**ADDENDUM  
NO. 1**

**March 17, 2025**

**PORTER LAKES ELEMENTARY SCHOOL  
ADDITION, RENOVATIONS, AND RELATED WORK  
Hebron, IN 46341**

This Addendum consists of Pages ADD 1-1, Specification Section 00 34 10 – Responsible Bidding Practices, and attached Addendum No. 1 from Gibraltar Design, Inc. dated March 14, 2025 and consisting of 6 pages, Specification Section 07 41 13 – Aluminum Roofing and 28 drawings.

© GIBRALTAR DESIGN SHEET  
**S-301**

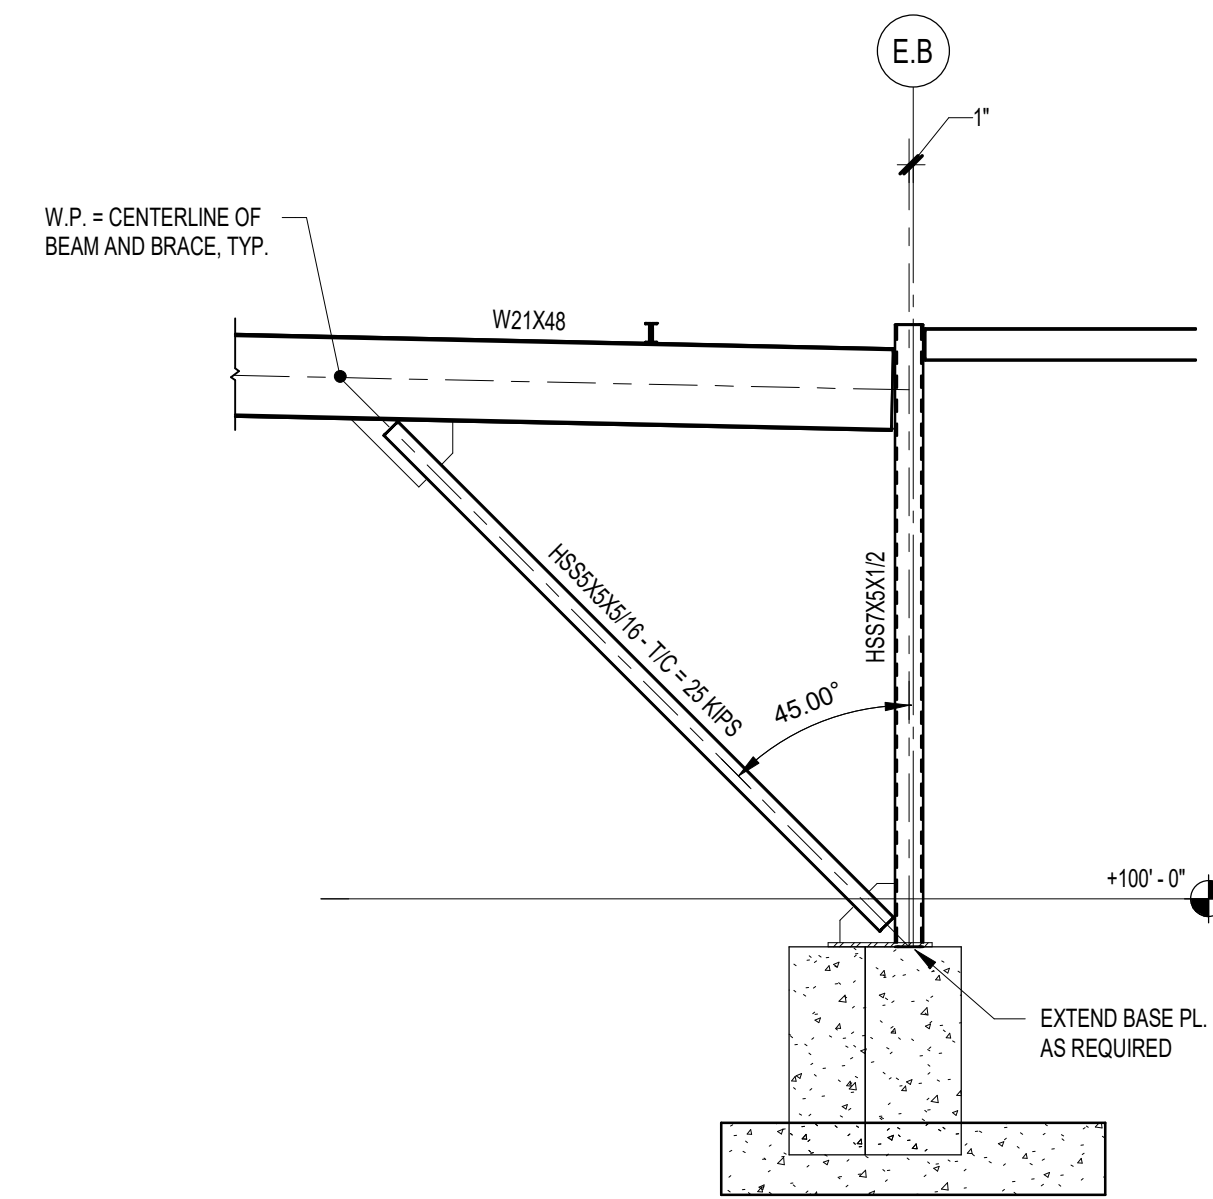
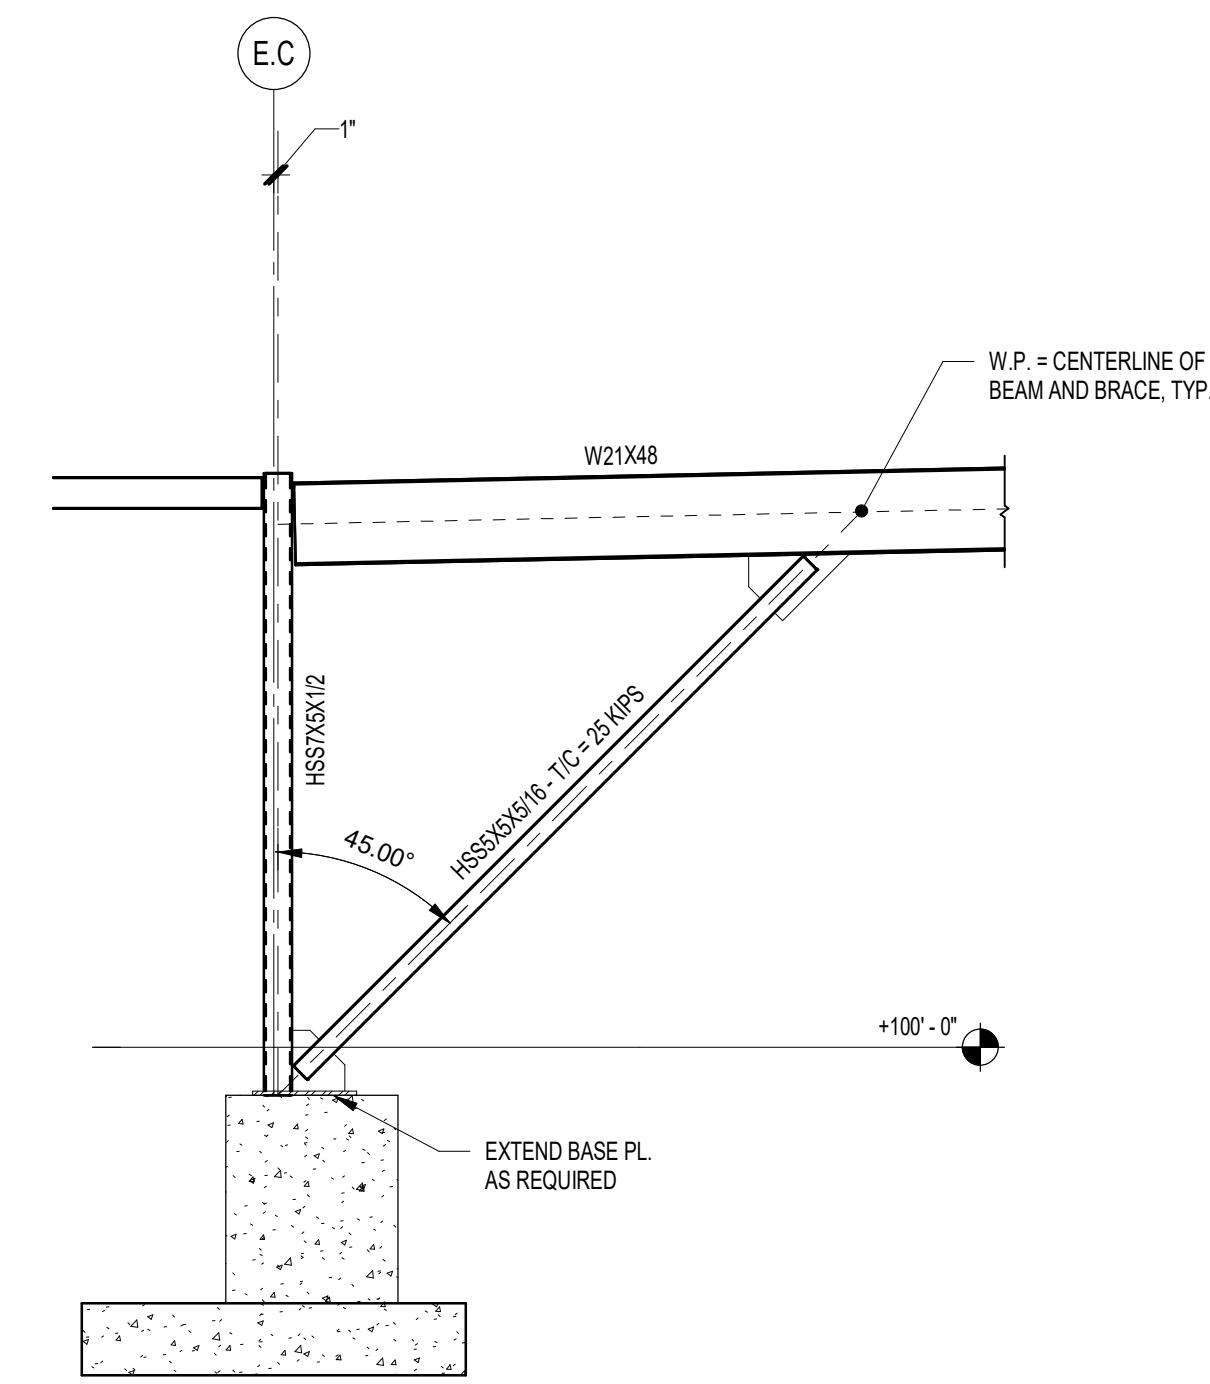
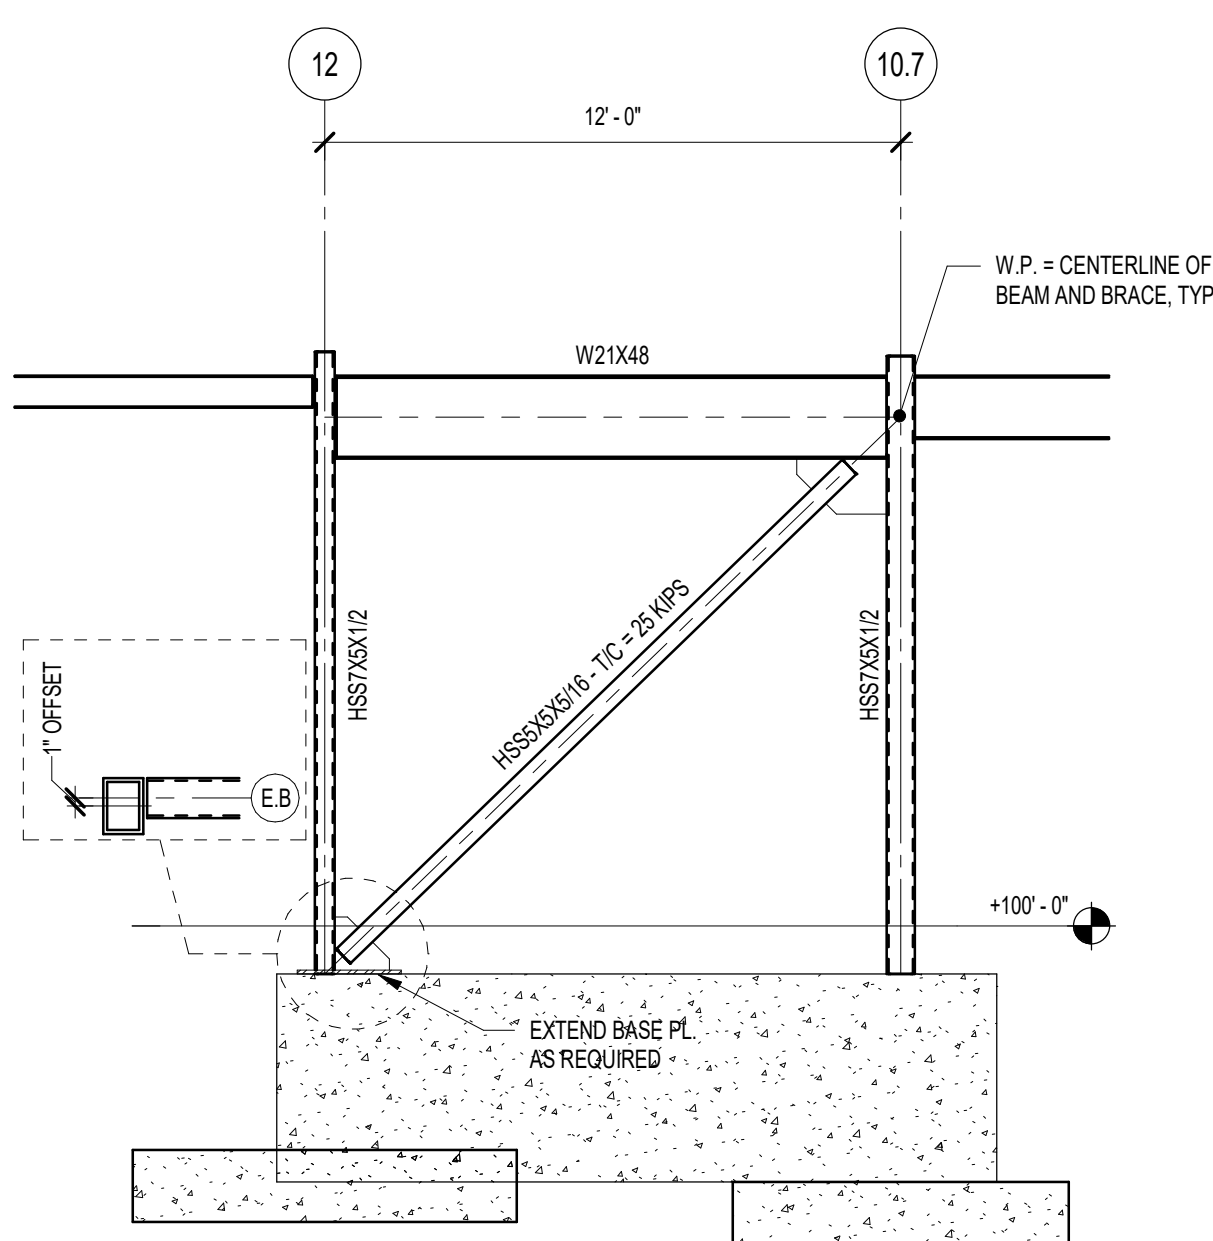
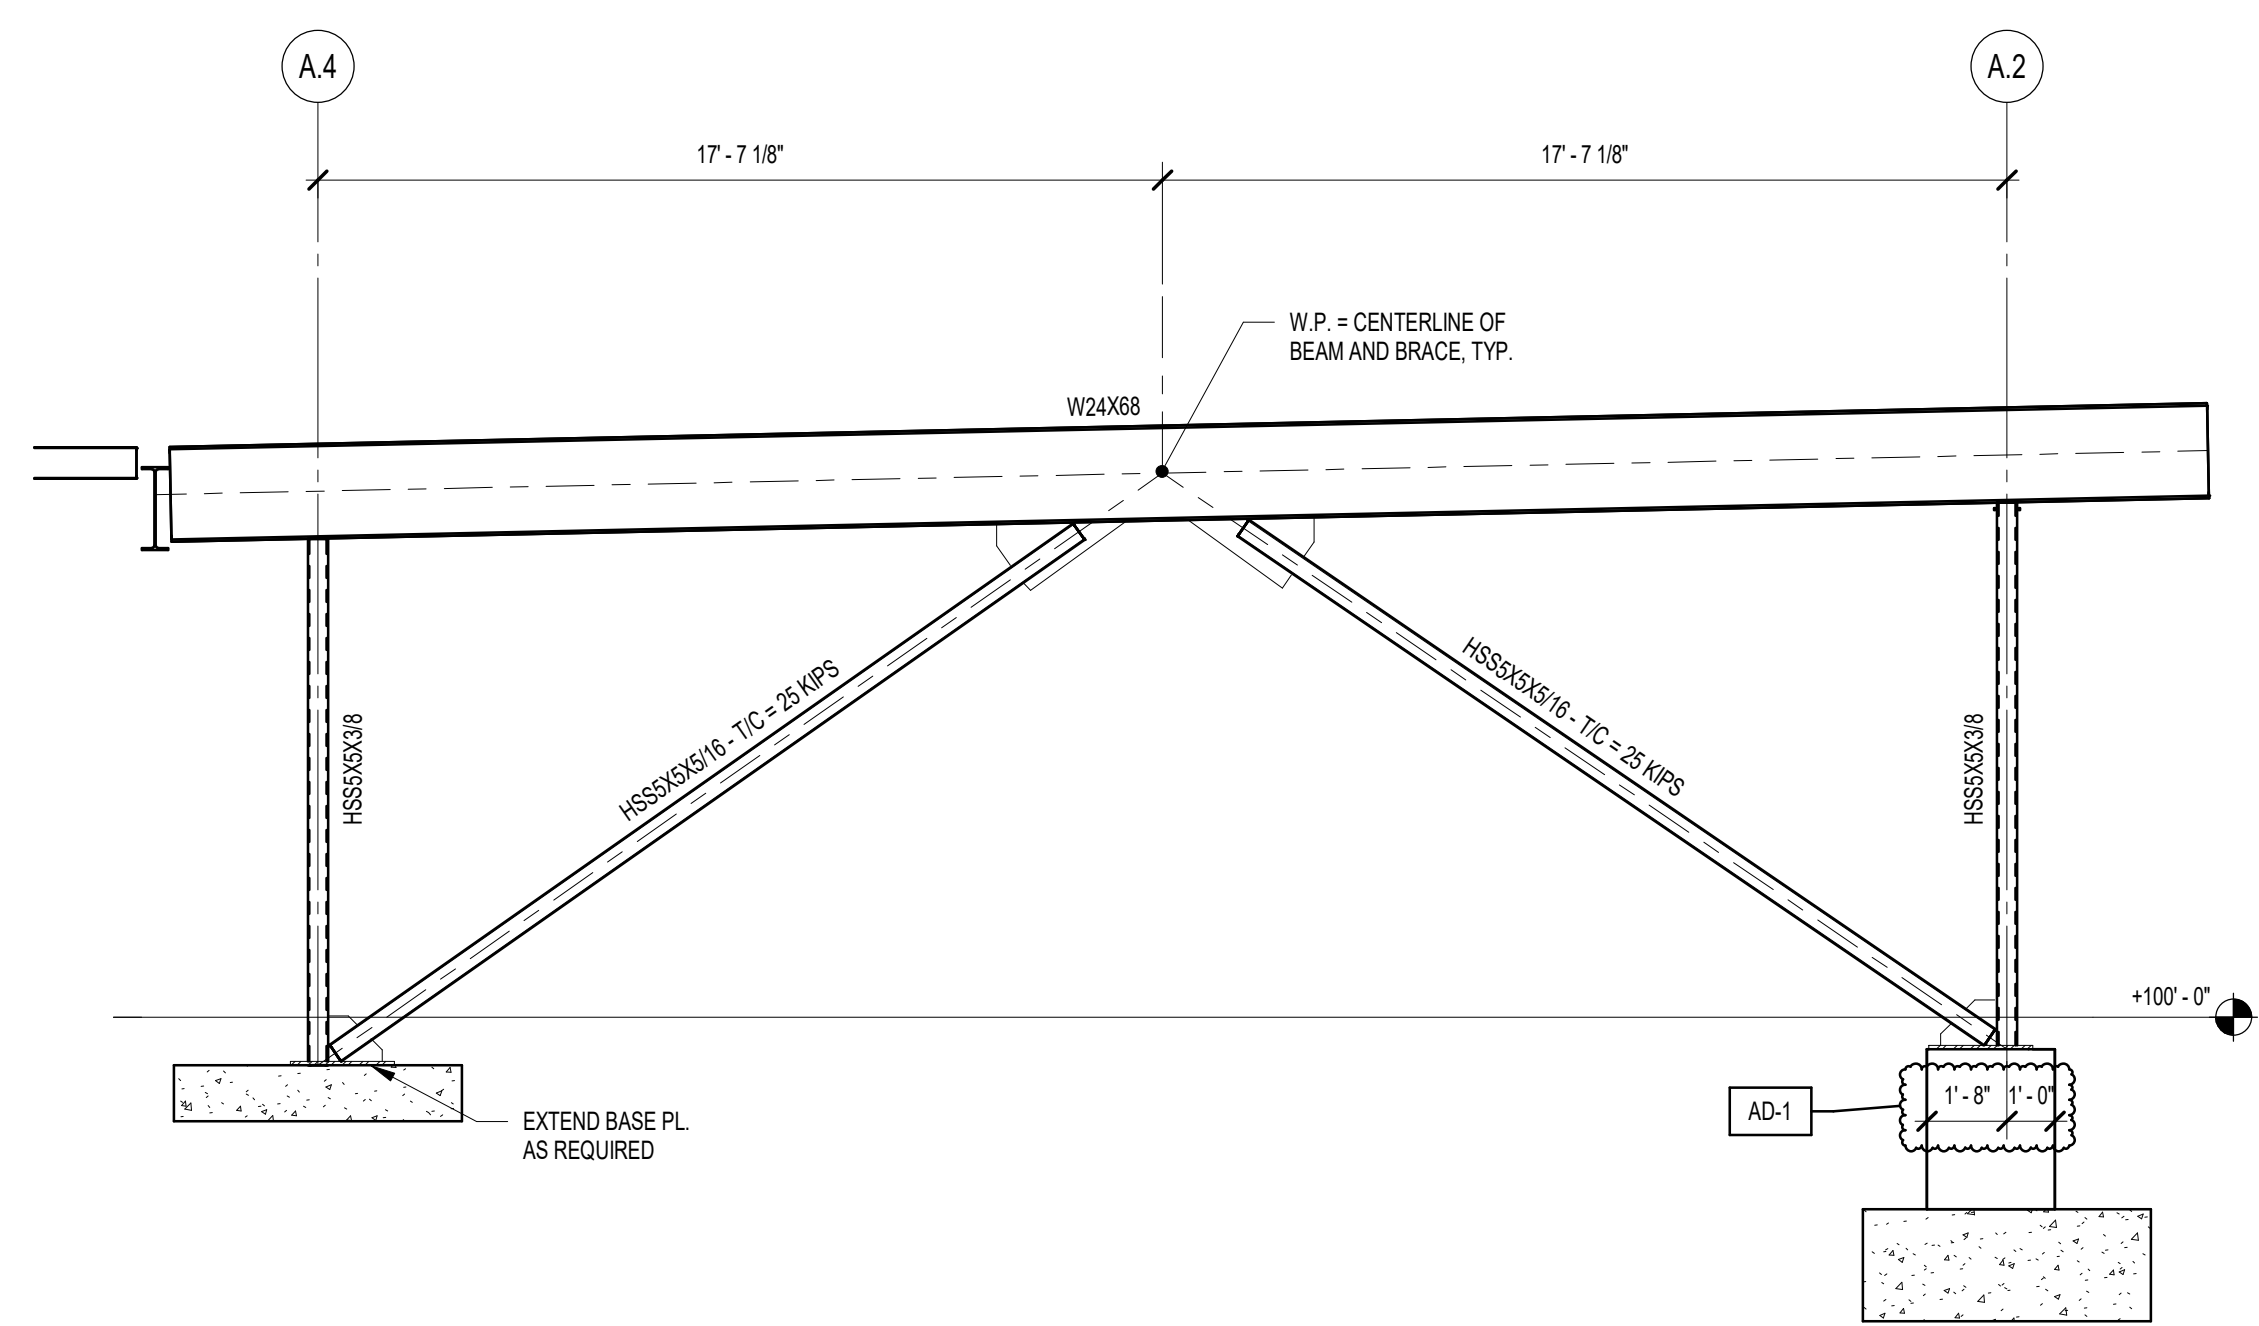
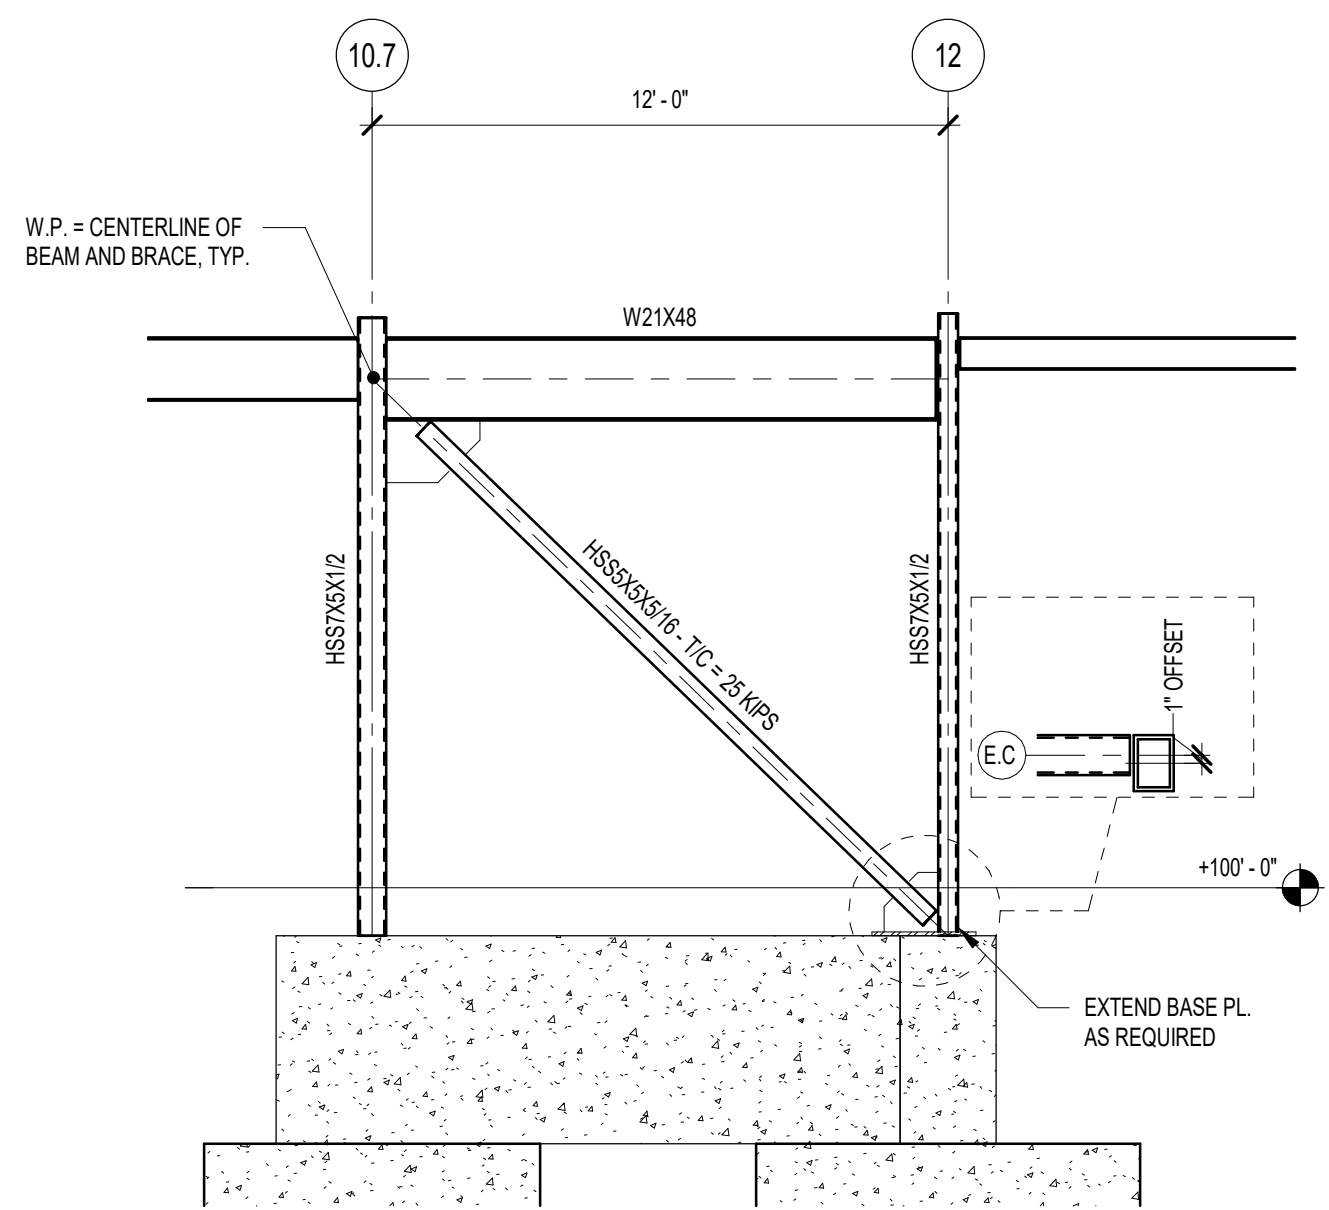
- A. Refer to revised, full-size drawing, included in this Addendum, for revisions.
  - 1. Concrete Piers Modified
